# Inspection Photos

API: 05-071-07915

Operator: ARP PRODUCTION COMPANY  
WAPITI OPERATING LLC

Inspection Date: 7/19/2019

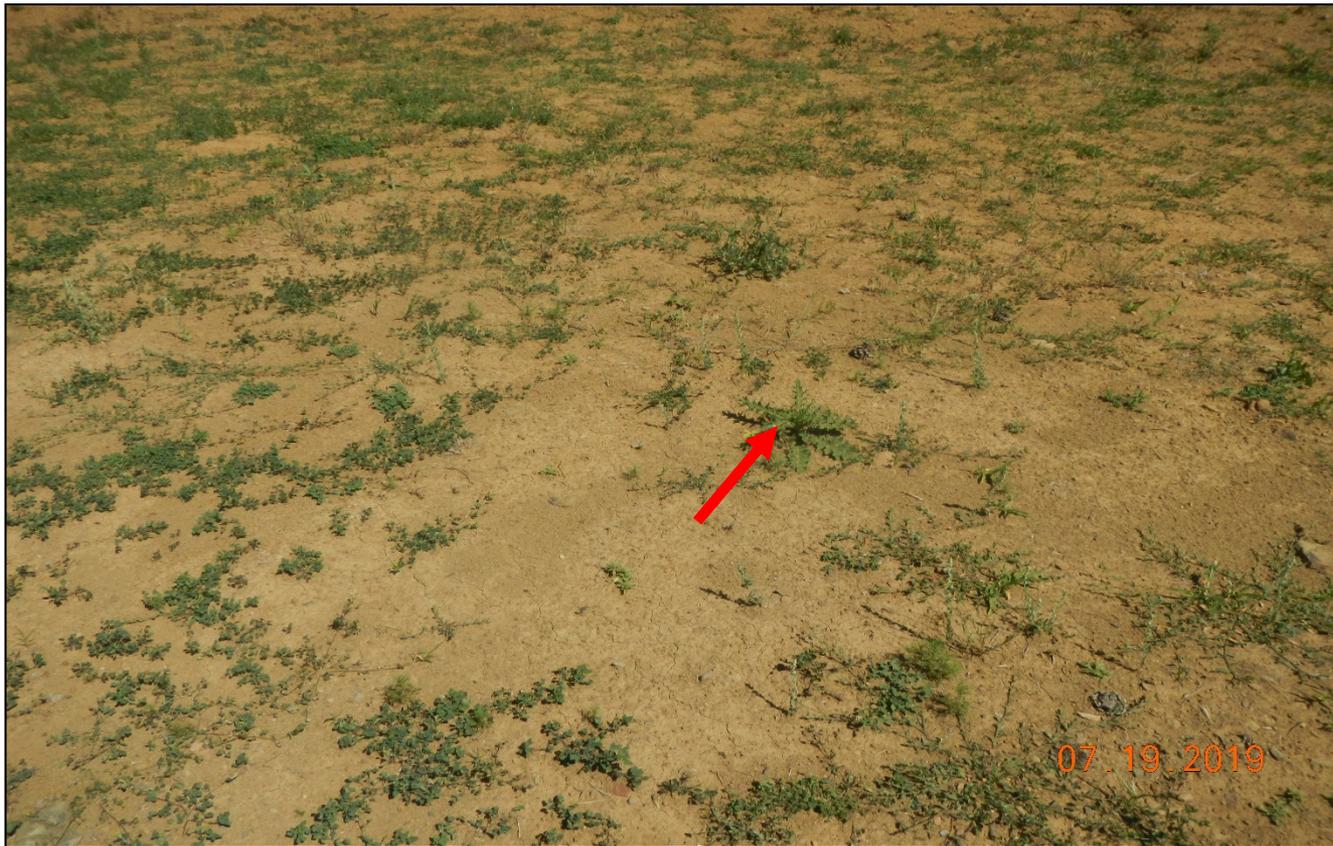
**Photo 7.** There are numerous first year Houndstongue that have not been controlled along the cut slope. The cut slope is not stabilized. Corrective action was not completed since previous inspection.
